# TECHNICAL INFORMATION

89500  
August 2010

**Subject** ▶ Change of Switch Lever

**For Models** ▶ AT-3623, BBC231U

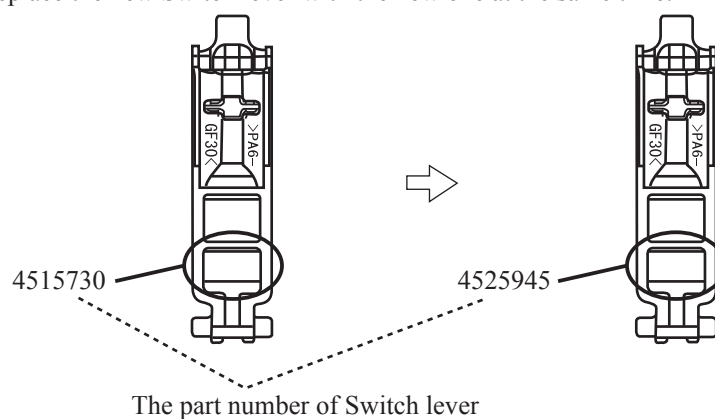
**Description** ▶ Switch lever has been changed as illustrated below to ensure the clearance between Switch lever and Plunger.  
When replacing the current Switch of Product Nos. 1001E to 1890E with the new one, replace the new Switch lever with the new one at the same time.

Item No.	Current part		Q'ty	I/C	New part		Q'ty	Note
009	Switch Lever 451573-0		1	←	Switch Lever 452594-5		1	
013	Switch TGR3-2 650629-8		1	See above.	Switch TGR3-2 650629-8		1	See above. The part No. remains the same.

From July 2010 production
